## **McRAE PLACE SUBDIVISION**

APPLICATION NUMBER 9 DATE September 1, 2005

REQUEST Subdivision

# DETAIL SITE PLAN

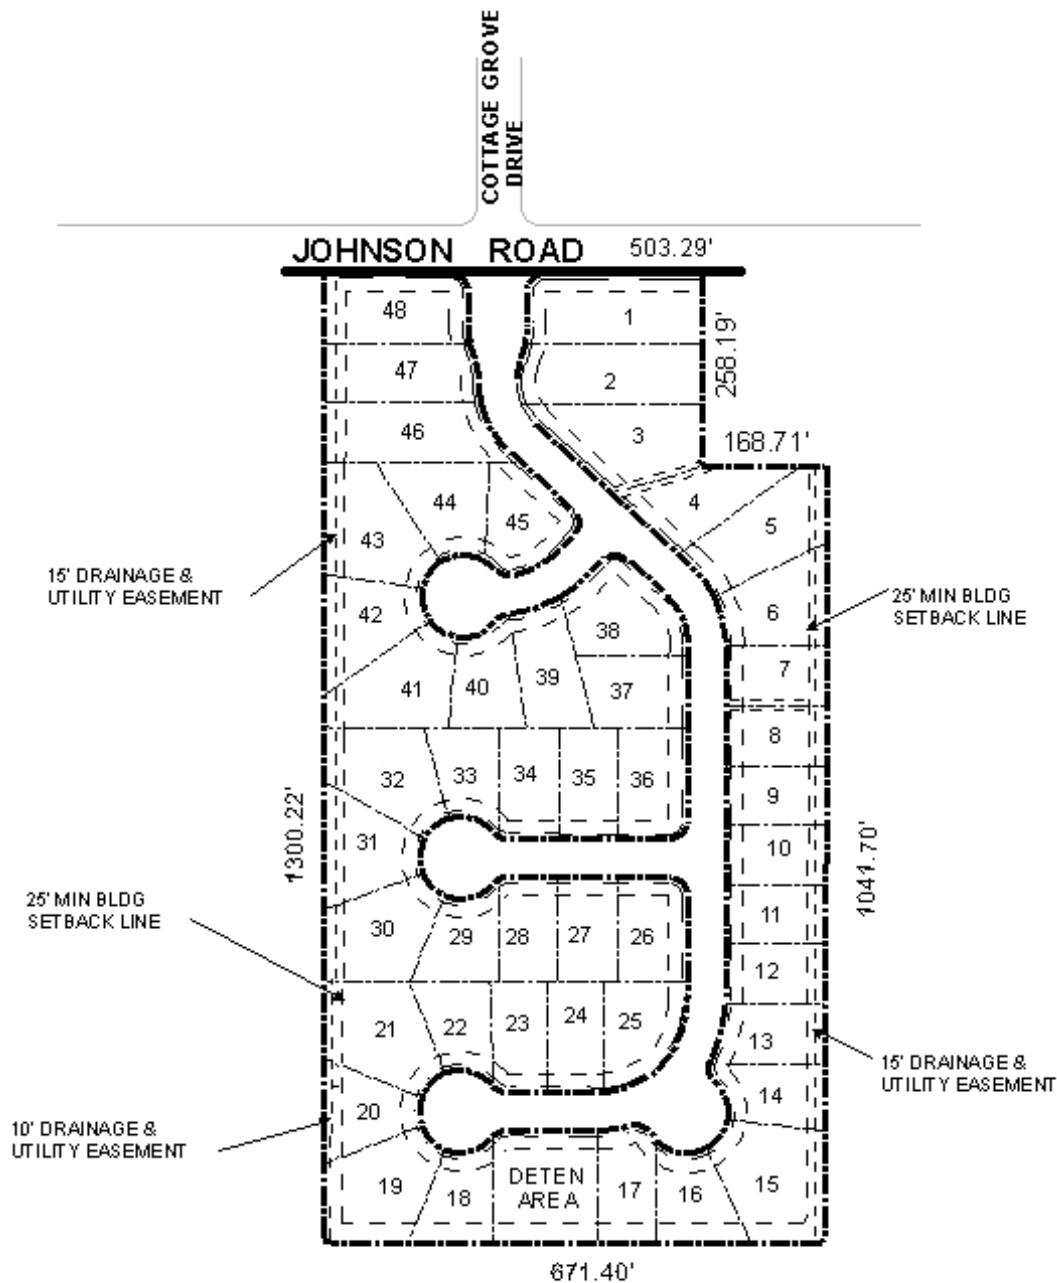
The site fronts Johnson Road South, which has a 60-foot right-of-way, and involves the creation of new streets, which should be constructed and dedicated. Two similar subdivision plats have been approved for this site but never recorded. One condition of previous approvals has been the provision of a street stub West, to connect with the Spring Brook Farms subdivision; this phase of Spring Brook Farms has not yet been recorded, but a condition of that approval is the provision of a street stub East. As recent plats of Spring Brook Farms show this street stub projecting South of the McRae Place site, it is recommended that, for McRae Place, a street stub South (instead of West) be required, for future connection with Spring Brook Farms.

As access management is a concern, a note should be required on the final plat stating that Lots 1 and 48 are denied direct access to Johnson Road South.

The plat illustrates a detention area; thus a note should be required on the final plat stating that maintenance of the detention area will be the responsibility of the property owners.

The plat meets the minimum requirements of the Subdivision Regulations and is recommended for Tentative Approval, subject to the following conditions: 1) the provision of a street stub to the South; 2) the placement of a note on the final plat stating that Lots 1 and 48 are denied direct access to Johnson Road South; 3) the placement of a note on the final plat stating that any lots that are developed commercially and adjoin residentially developed property must provide a buffer, in compliance with Section V.A.7 of the Subdivision Regulations; and 4) the placement of a note on the final plat stating that maintenance of the detention area will be the responsibility of the property owners.
